NORTH FALLS

Flood Risk Assessment (Clarification regarding flood risk associated with watercourse crossings) - Technical Note

Document Reference: 9.46
Volume: 9
Date: April 2025
Revision: 0

Figure 7-3: LiDAR DTM with Contour Lines and Flood Map for WX-23

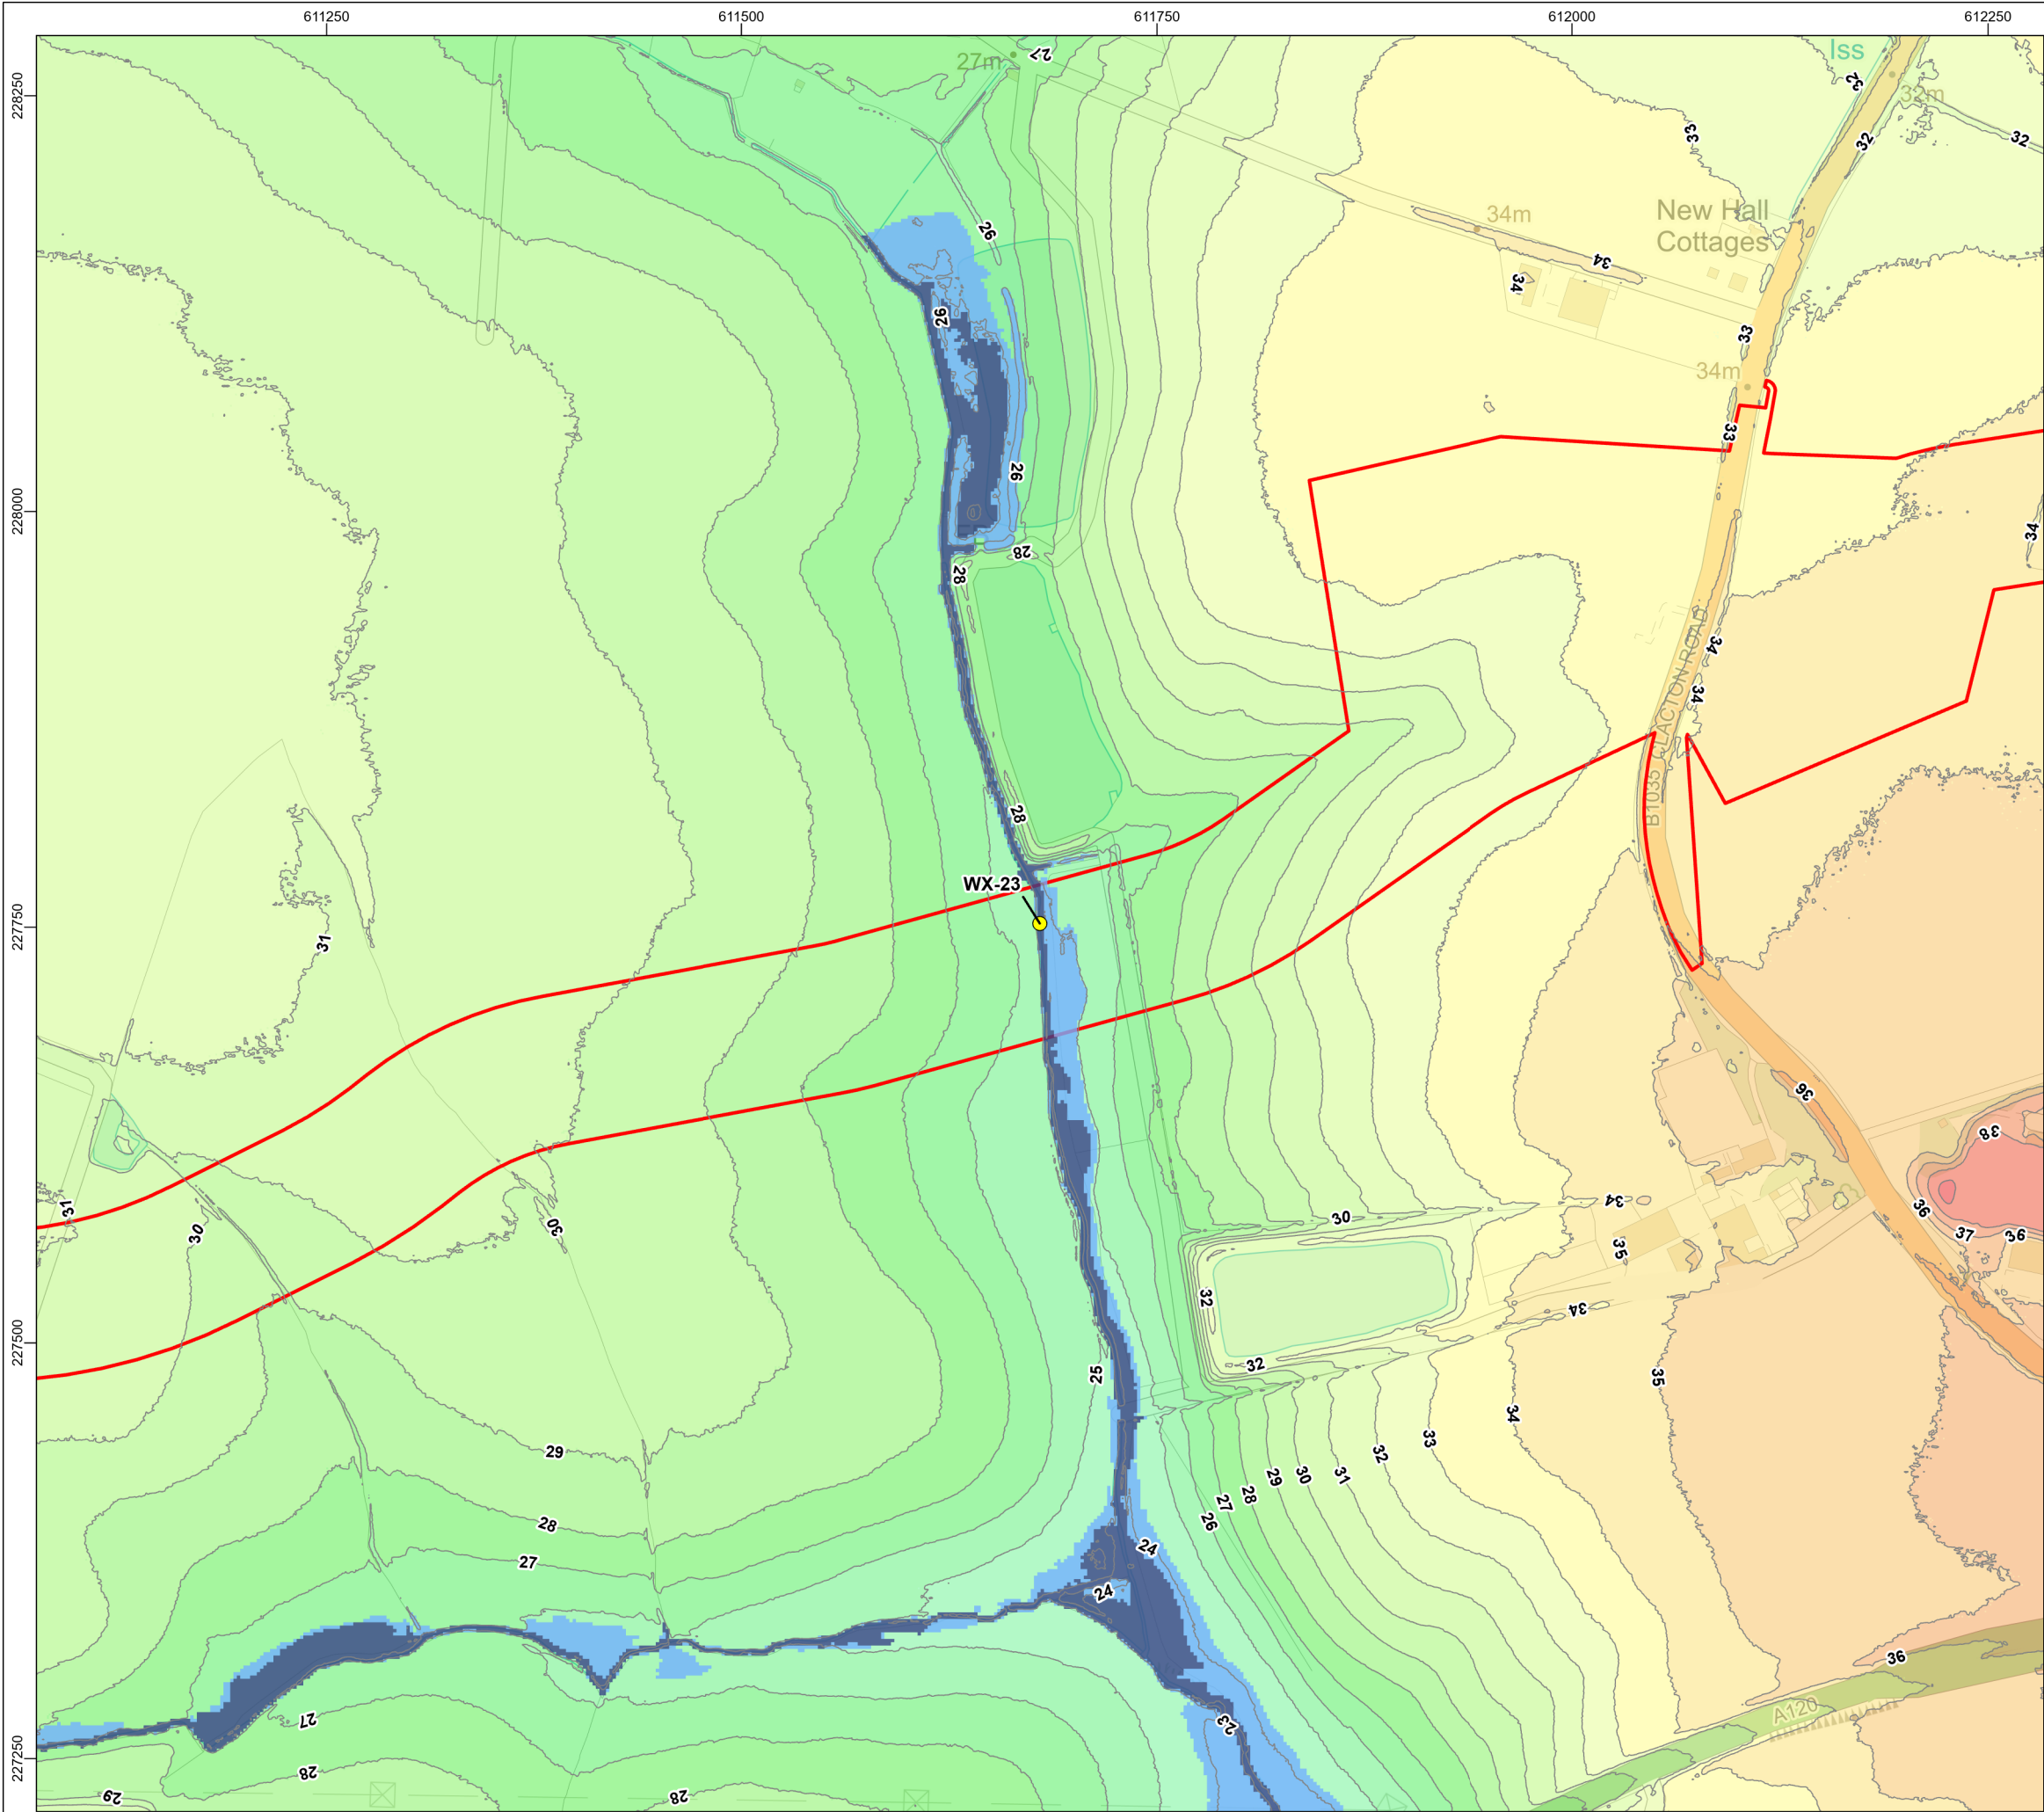
79. Along the left bank (located to the east) of the river channel, the elevation increases from 24mAOD at the channel up to 34mAOD along the B1034 which is located approximately 350m to the east.

80. Located approximately 340m to the south-east of Holland Brook there is one potential residential receptor which is Abbot's Hall. This is located at an elevation of 35mAOD, which is approximately 11m above Holland Brook.

Figure 7-4: Old and New Flood Maps for Planning from Rivers and Sea at WX-23

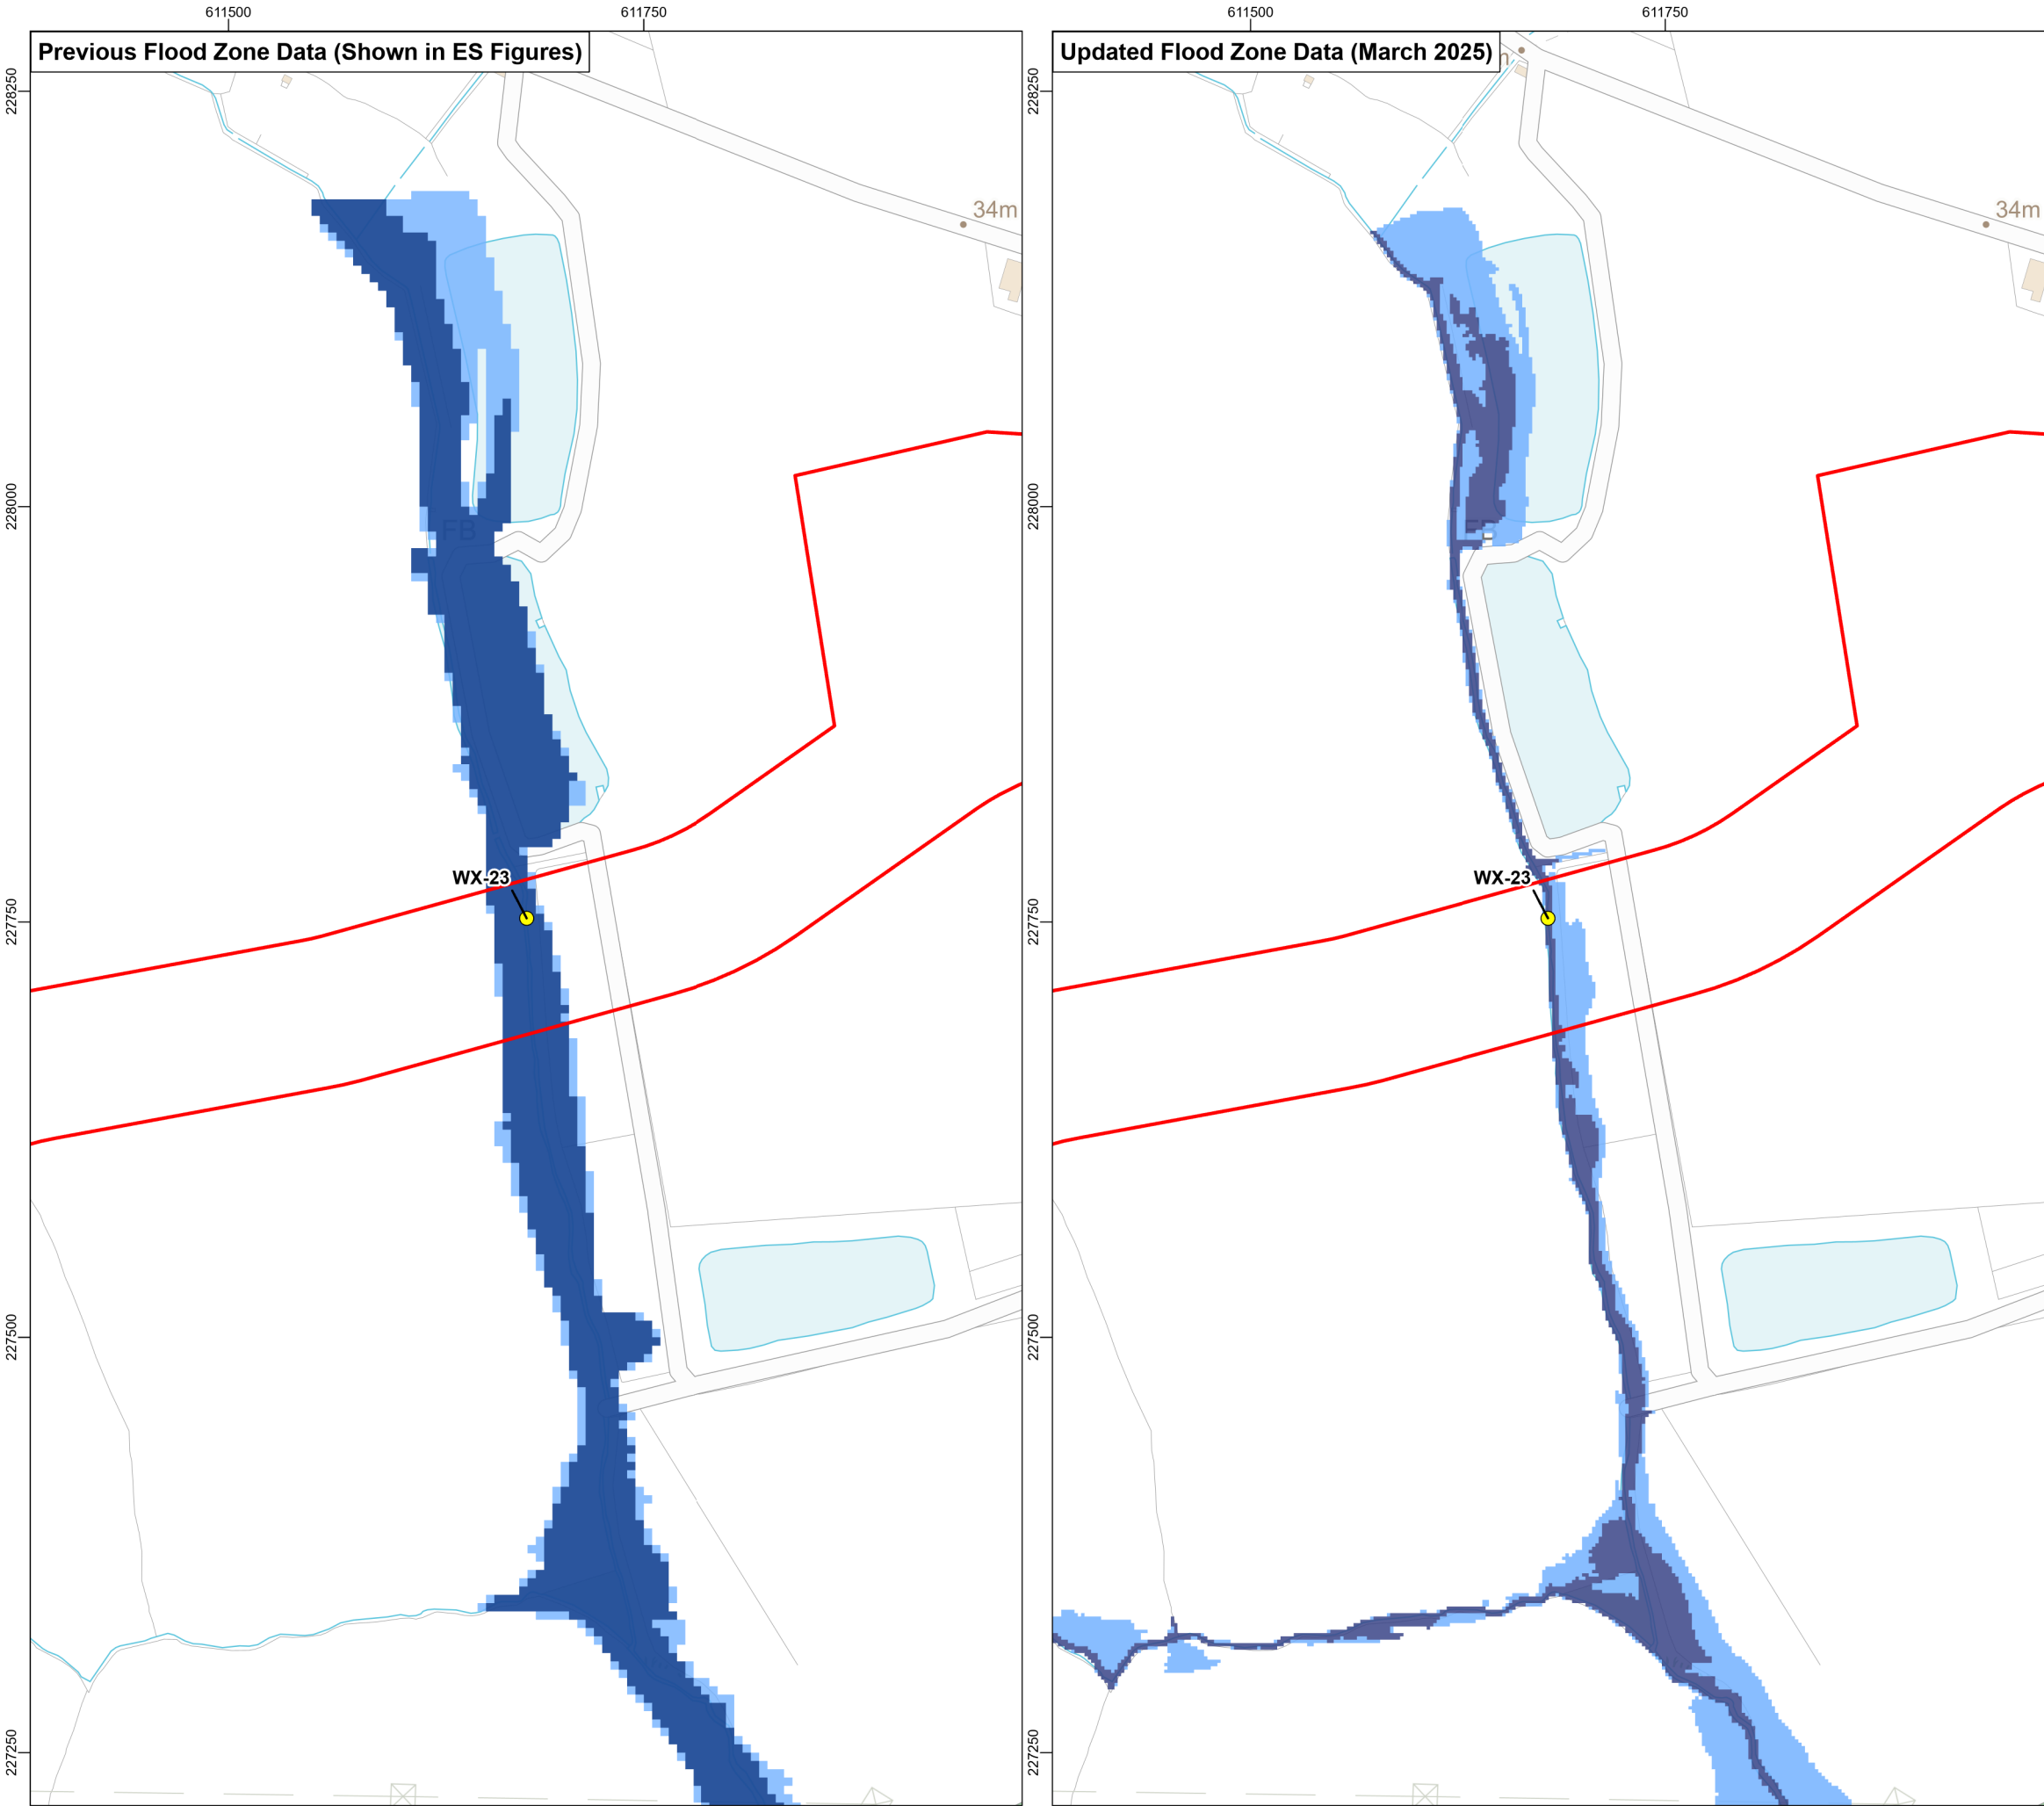
86. The updated Flood Map for Planning indicates that at WX-23 the Flood Zone 3 extent remains in-channel.
87. The Flood Zone 2 extent expands slightly out of the left bank, which it is assumed is due to the LiDAR having similar elevations to the channel. However, as a result of the elevation increasing to 25mAOD on the left bank, Flood Zone 2 cannot extend past this point due to the topography.

88. When comparing the updated Flood Map for Planning with the superseded Flood Zone mapping, it indicates that Flood Zone 3 no longer exceeds its banks and remains in-channel.

89. Furthermore, Flood Zone 2 on the right bank is reduced and only exceeds the channel on the left bank. This is as a result of the right bank having a slightly steeper immediate topography of 26mAOD, although the ground then drops away to lower elevations.
